# **PRODUCT CHANGE NOTICE**

**Alternate Manufacturing Site  
for Assembly of the Listed  
Intersil QSOP and SC-70  
Packaged Products**

**Refer to:  
PCN12091**

**Date: December 4, 2012**

# PCN12091 – Current POD QSOP 16I and 24I

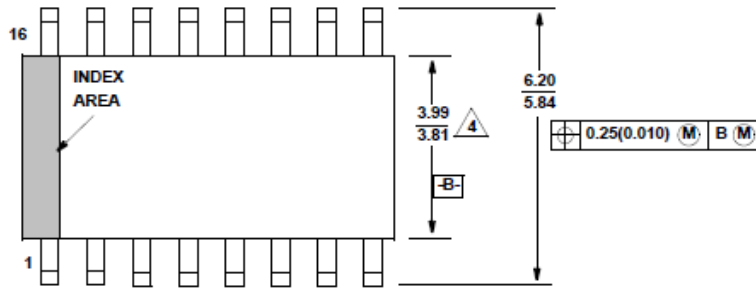
The Carsem (CAM) facility is ISO 9001:2008, TS 16949:2009, and ISO 14001:2004 certified. The CAM facility is qualified as a supplier to Intersil for performing assembly of packaged products, including the QSOP and SC-70 package styles. There will be no change in the die attach, bond wire (material or diameter), frame material, or moisture sensitivity level (MSL). The 16I QSOP, 24I QSOP, and select 6I SC-70 packaged devices will require minor dimension changes to the package outline drawings (POD). The affected PODs and a summary containing a list of products along with the current and new PODs are included for reference. The material set combinations for assembly and other key items are as follows:

Key Items	Unisem - Current		Carsem M - New (Alternate)	
	QSOP	SC - 70	QSOP	SC - 70
Mold Compound	SG600	SG600	SG600	CEL9220HF13
Die Attach	A8290	84-1LIMSR4 or A8006NS	A8290	84-1LIMSR4 or A8006NS
Bond Wire - Gold (Au)	1.0 or 2.0 mil	1.0 mil	1.0 or 2.0 mil	1.0 mil
Moisture Sensitivity Level	2 or 3	1, 2, or 3	2 or 3	1, 2, or 3
Frame Material	C194	C194	C194	C194
Device Marking - Site Code	B	B	G	G
